PLEASE CONFIRM:

TRASMITTER FOR MODEL 08037

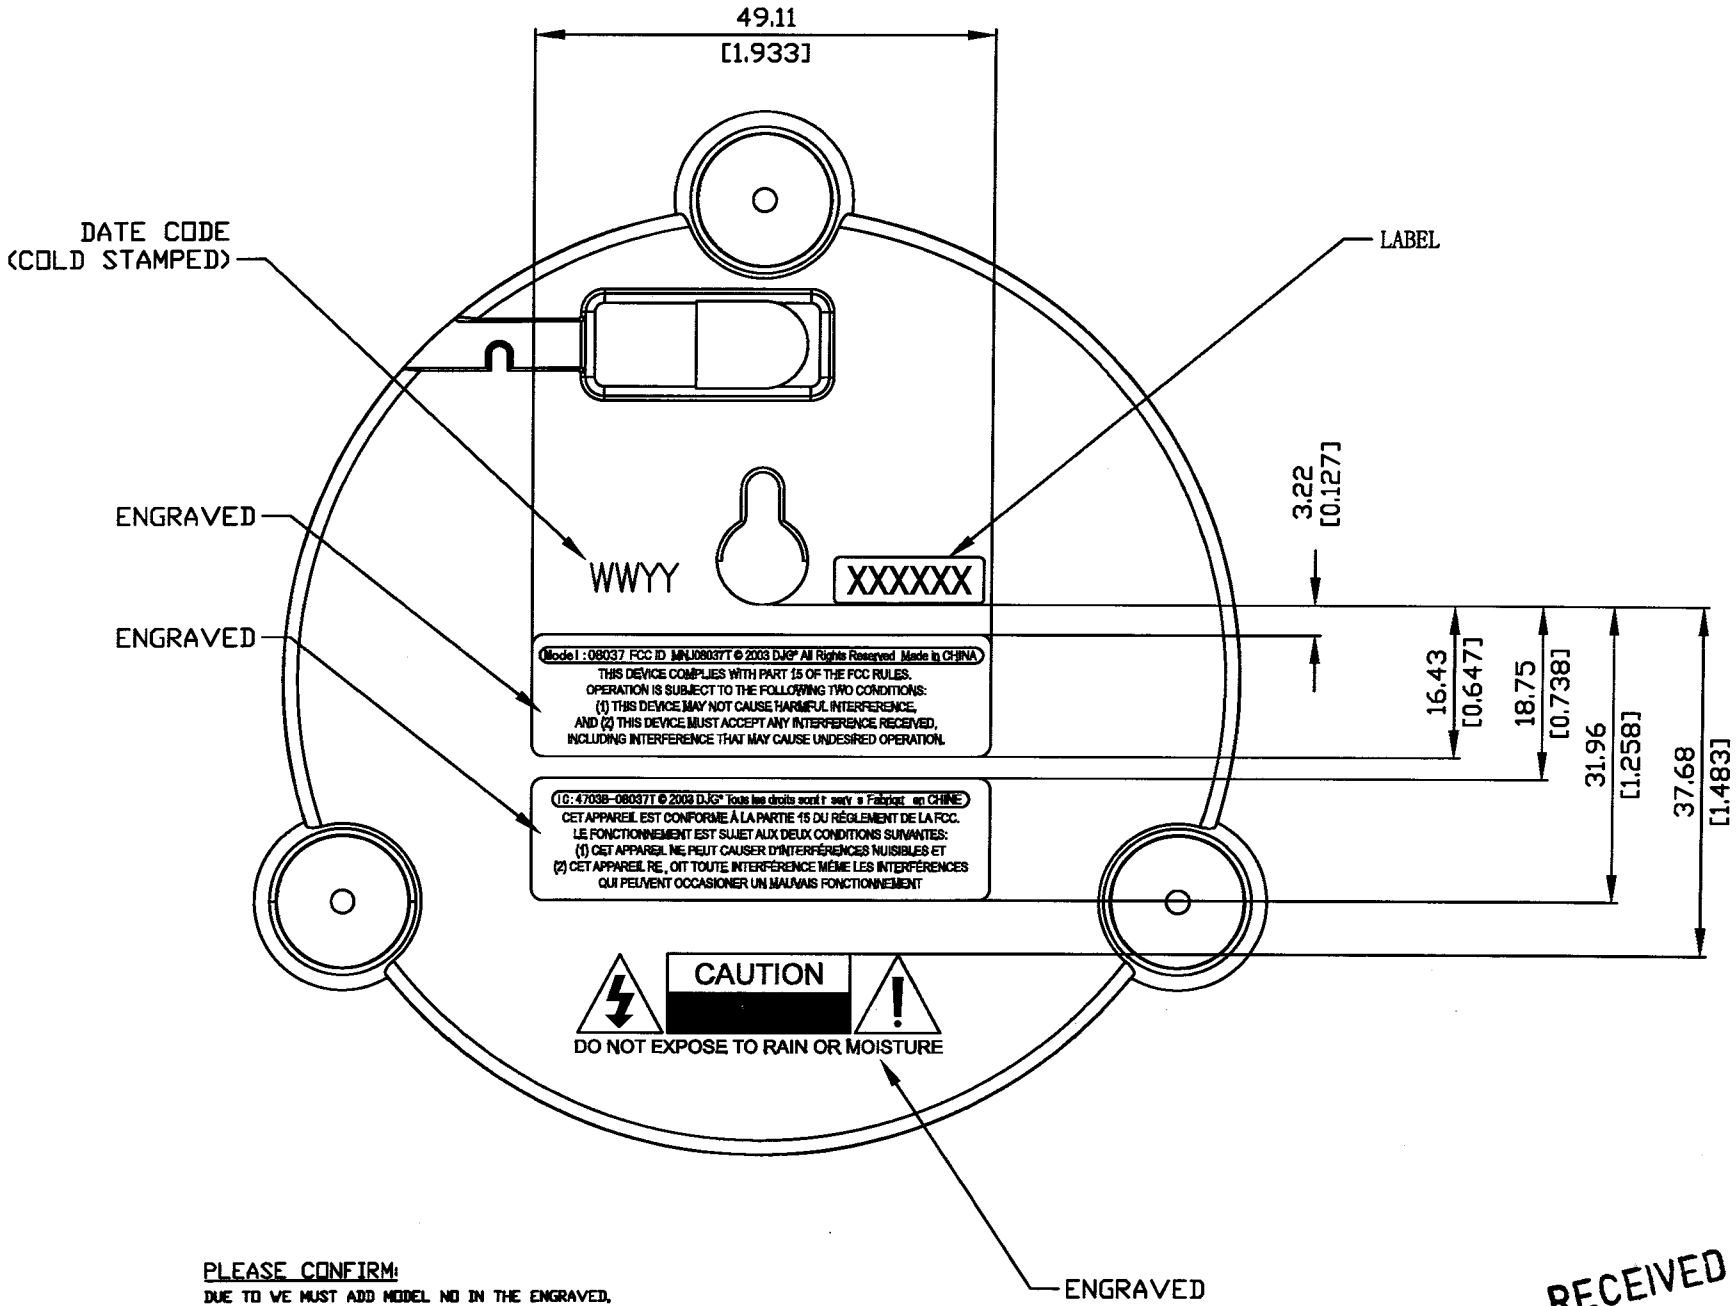
DUE TO WE MUST ADD MODEL NO IN THE ENGRAVED,
WE HAVE TO CHANGE THE SIZE OF INSERT FROM 48.11 TO 49.11,
THAN WE CAN NOT PLACED THE INSERT HORIZONTAL.
PLEASE CONFRIM THIS NEW STATION AS ABOVE.
